APPLICATION NO.	FILING DATE	FIRST NAMED INVENTOR	ATTORNEY DOCKET NO.	CONFIRMATION NO.
10/533,108	05/27/2005	Josef Weiland	LORWER P37AUS	4794
20210 7590 06/02/2008 DAVIS BUJOLD & Daniels, P.L.L.C. 112 PLEASANT STREET CONCORD, NH 03301				
EXAMINER				
MULLER, BRYAN R				
ART UNIT		PAPER NUMBER		
3723				
MAIL DATE		DELIVERY MODE		
06/02/2008		PAPER

Office Action Summary

DETAILED ACTION

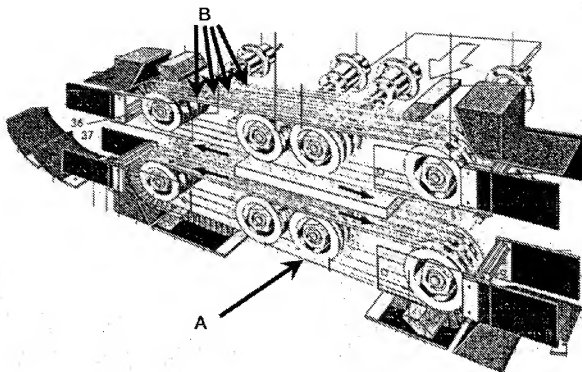
22. Finally, with regard to claim 46, the applicant further argues that there is no clear reference that conveyor devices are offset from one another on each side of the Ingromat device. However, for clarification, the Examiner has included a drawing taken from the Ingromat reference to specifically point out the brush conveyors that are offset from one another and rotate in opposite directions. The applicant also argues that the offset brushes of the Ingromat apparatus would not provide the same advantages as the applicant's claimed invention because the Ingromat reference puts no pressure on the brushes. However, as discussed *supra*, the Ingromat apparatus is capable of applying pressure between the brushes and the workpiece and regardless of the applicant's intended advantage, the Ingromat reference does provide all of the limitations regarding

the positioning of the conveyor devices relative to one another, as they are claimed in claim 46. Therefore, the applicant's intended advantage is moot in the apparatus claims.
